N00164.AR.002587
NSA CRANE
5090.3a

EMAIL REGARDING U S NAVY RESPONSES TO U S EPA REGION V COMMENTS ON THE DRAFT FINAL INTERIM MEASURES REPORT FOR SOLID WASTE MANAGEMENT UNIT 17 (SWMU 17) PCB CAPACITOR BURIAL POLE YARD NSA CRANE IN
2/22/2016
NAVFAC MID ATLANTIC

CONTRACT NUMBER	CTO NUMBER
—	F271
APPROVED BY	DATE
—	—
APPROVED BY	DATE
—	—
FIGURE NO. 4-5	REV 0

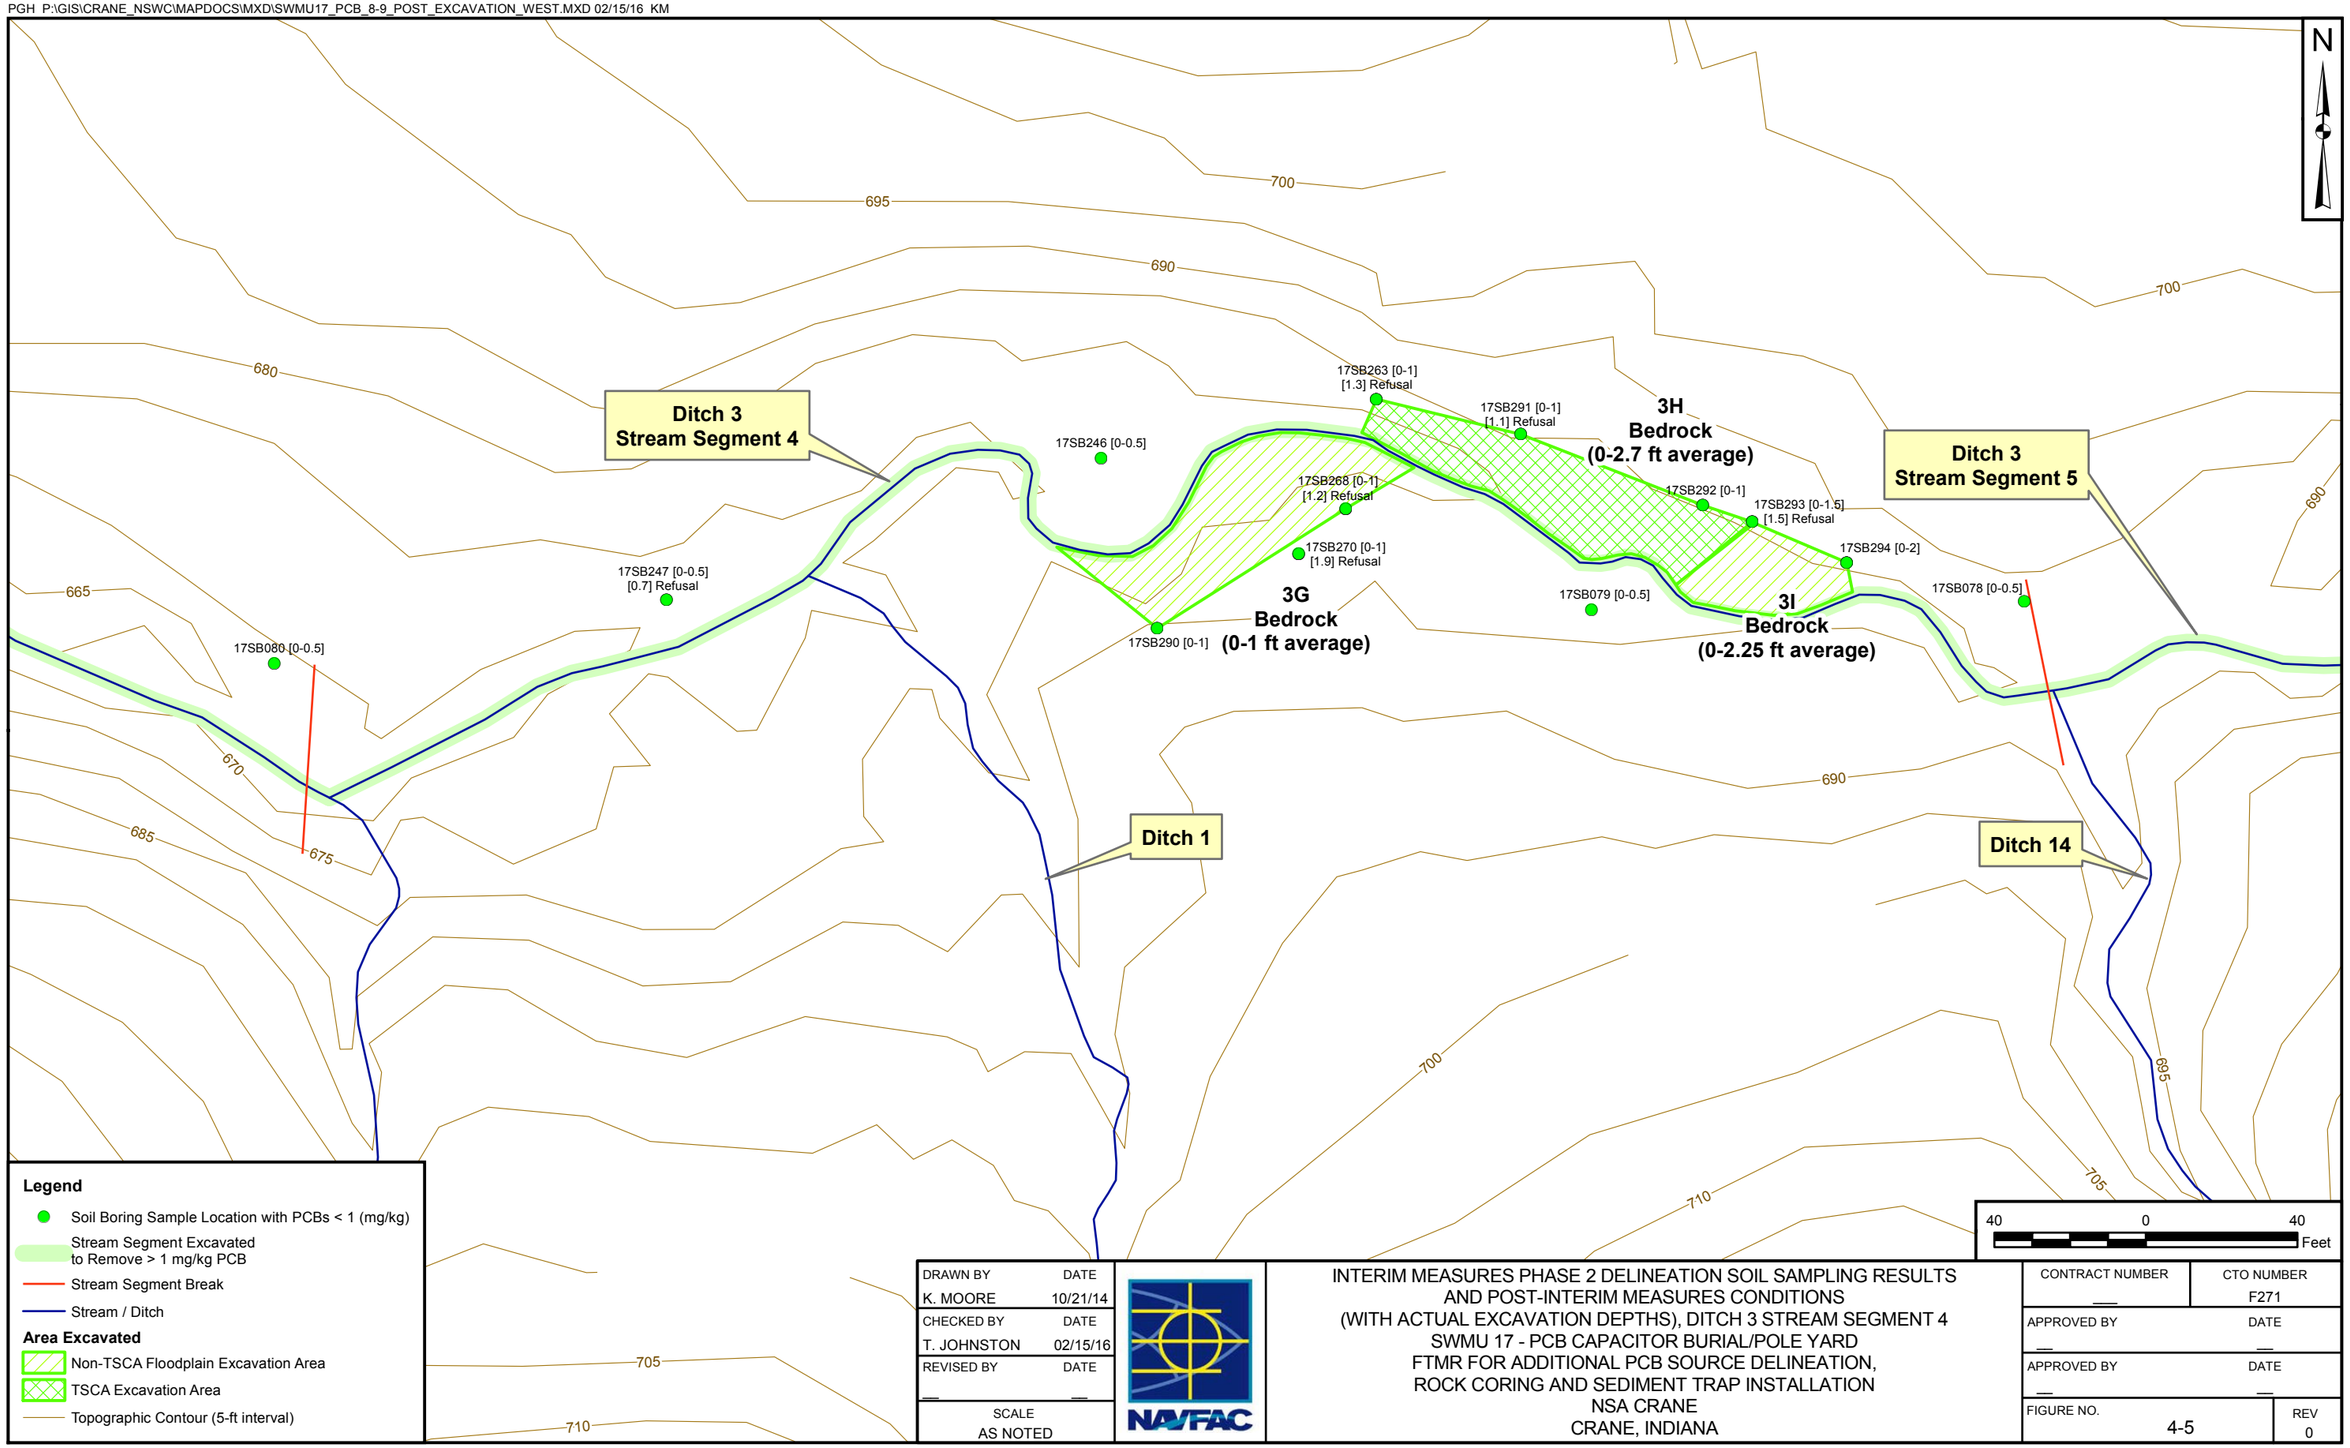
EPA Comment #3:
Figure 4-5 contains a spelling error for sample 17SB247: "Rufusal".

3) Figure 4-5 contains a spelling error for sample 17SB247: "Rufusal".

Navy Response #3:
The referenced spelling error on IMR Figure 4-5 has been corrected and a revised Figure 4-5 is attached. In addition, the IM report has been double checked for typographical errors and, if found, typos were corrected. One error ("Corresponding" was misspelled) was found in the header of Table 3-1, second to right-most column; otherwise no other errors were found. A revised Table 3-1 is attached.
